London, 7th January 2021

I am getting in touch with you again today to strongly reiterate my objection to the revised drawings submitted on the 13th_November_2020 for the Planning Application Number 2020/2839/P.

PROPOSAL SUBMITTED 13.11.2020 – ENCROACHES ON 39 AS THE ENTRANCE IS NO LONGER SET BACK FROM THE FRONT OF THE BUILDING

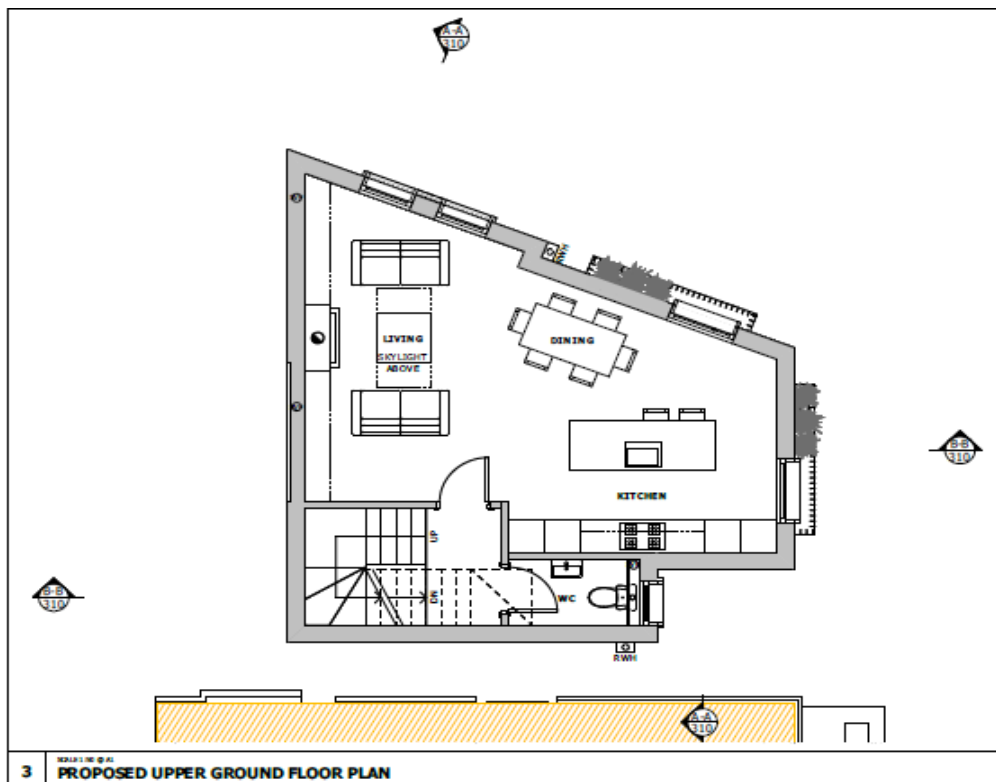
Going back to the revised plans I can't help noticing that they now bring forward the front line of the building at full height as you can see from the

This causes the planned building to be effectively much closer to n. 39 and it creates a narrow passage between the two buildings, not to mention the diminished amount of light. It also makes the whole site appearing, even more, as an unpleasant and bulky concrete structure, in total disagreement with the Conservation Area rules.

ORIGINAL PROPOSAL – ENTRANCE IS SET BACK AND THERE IS ONLY ONE WINDOW TO THE FRONT OF THE BUILDING

3 PROPOSED UPPER GROUND FLOOR PLAN

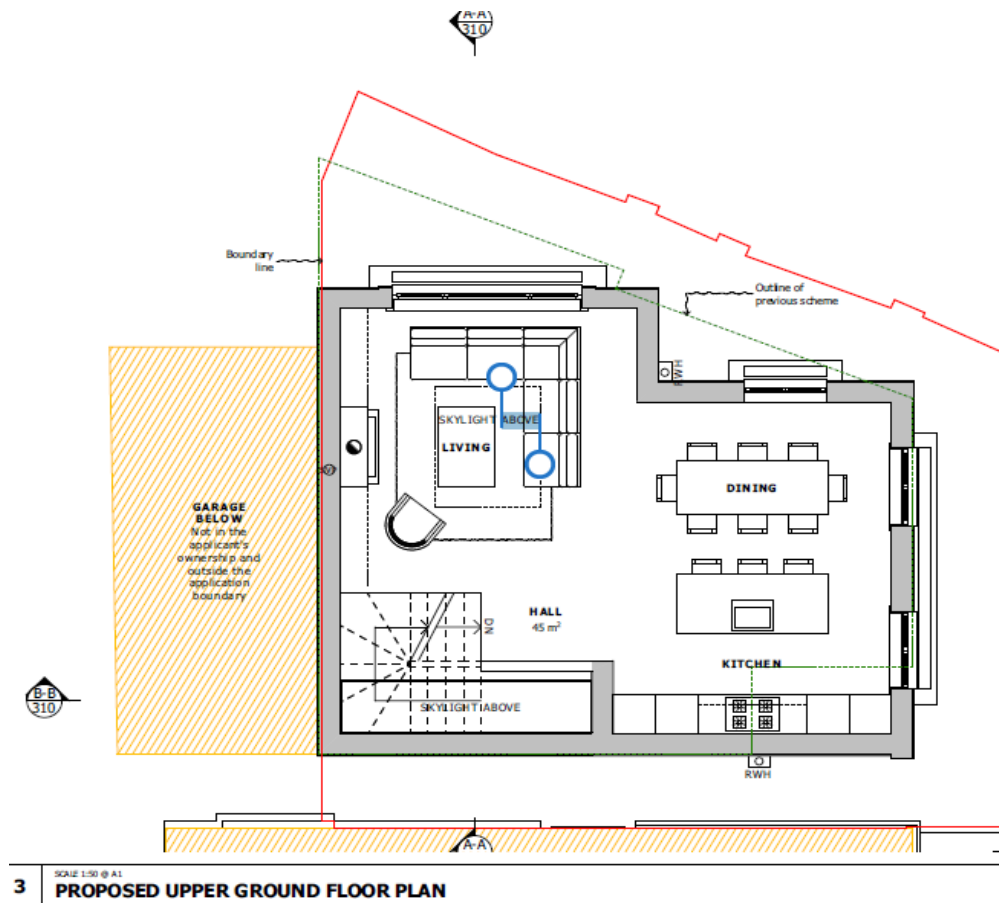
This is a very tiny piece of land. The proposed plans would result in an exaggerated over development of the site, where the size of the building is totally disproportionate compared to the size of the land available and the proximity of the other buildings.

LOCATION OF MANHOLE

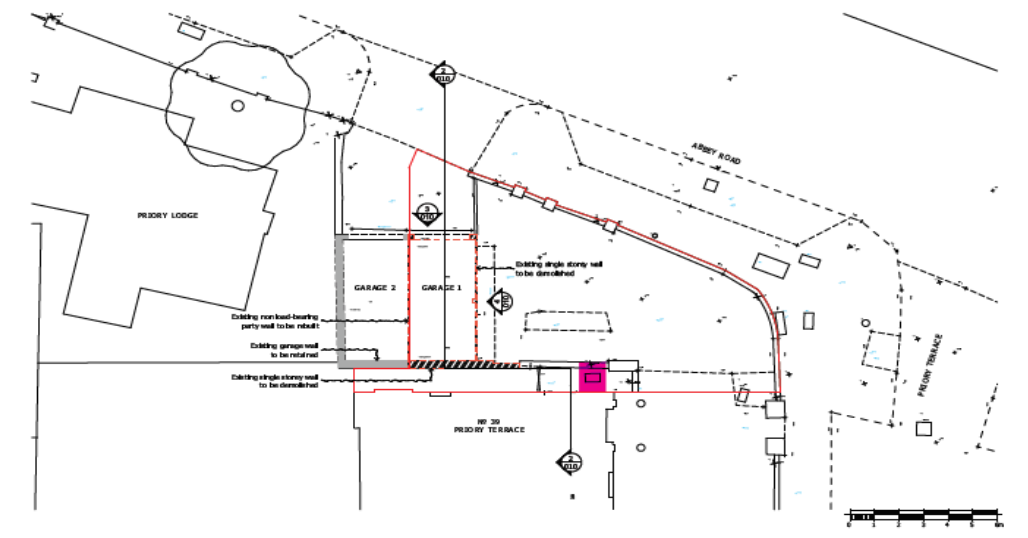
Also, I have highlighted in **purple** below the location of the manhole in the narrow passage between the buildings – there surely are drains running to that manhole and from it to the general area sewage.

CONTIGUOUS PILED WALL AND CAPPING BEAM WILL INTERFERE WITH THE EXISTING DRAINS AND MANHOLE

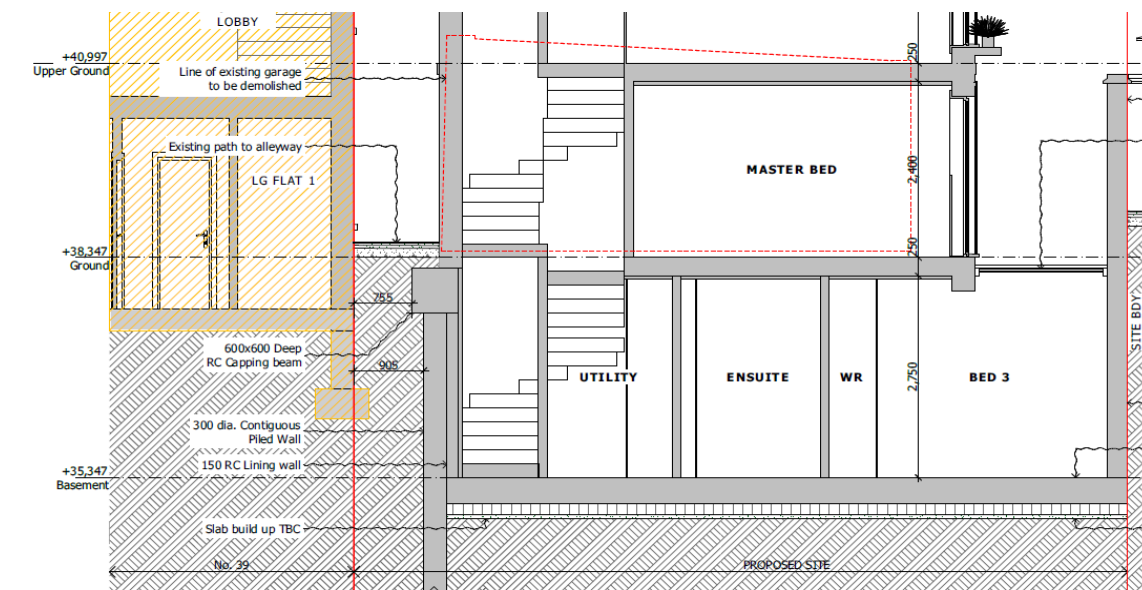
Please note the copy of the section from the revised plans showing the width of the pathway and the extent of the piles and beams.
This plan would therefore inevitably interfere with the current drainage of both the waste and rain waters.

Revised Ground Floor Plan proposed showing tree (green) and Cellular Attenuation Tank (blue)

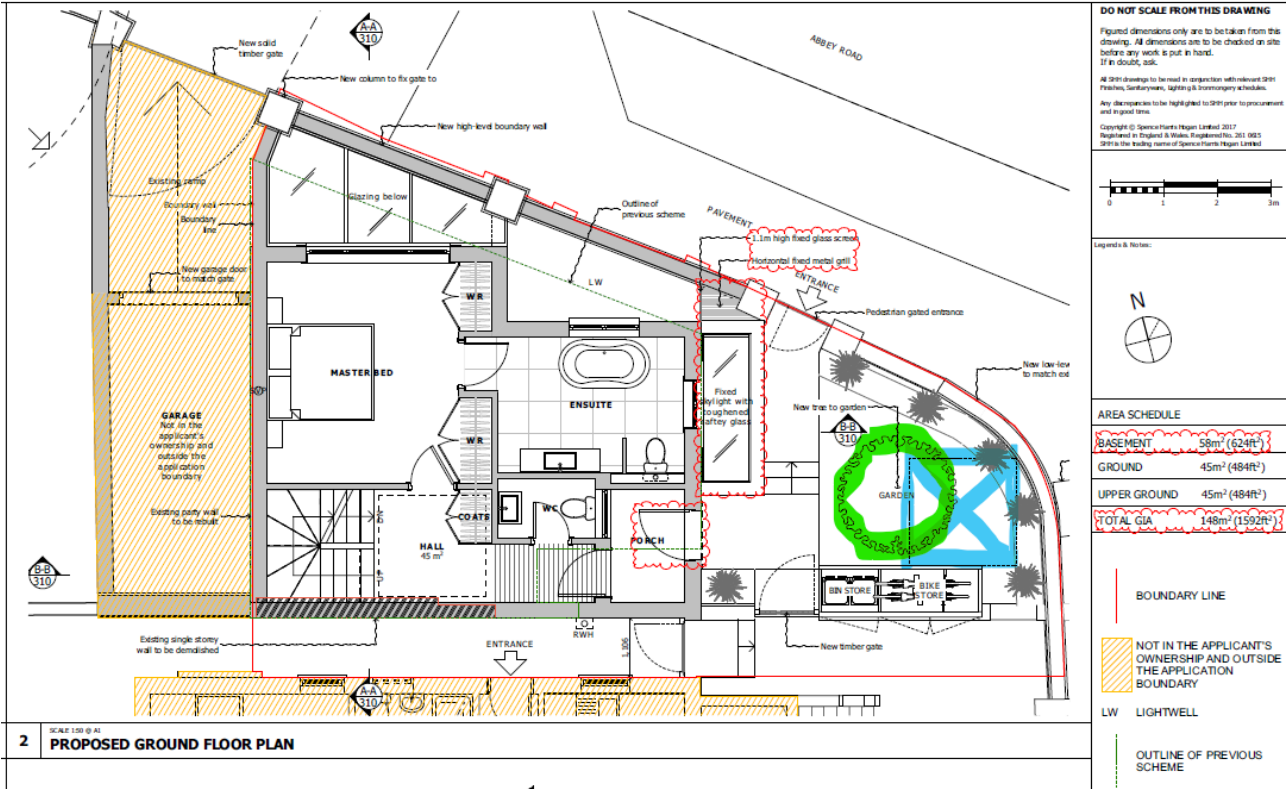
According to the SuDS Maintenance Guide a below-ground water storage system (please see the drawing below - highlighted in blue) requires regular monthly maintenance and inspection.

How can it be guaranteed that any future owners will ensure that this is carried out? or that he/she will employ and bear the costs of a maintenance organisation? We know this is impossible to guarantee. In which case, there can be the possibility of contamination or water stagnation, and the related consequences.

Moreover, the revised plans show a tree (in **green** in the drawing below) to be planted above the 2m x 2m storage tank and the roots can easily interfere and damage the tank ahead of time.
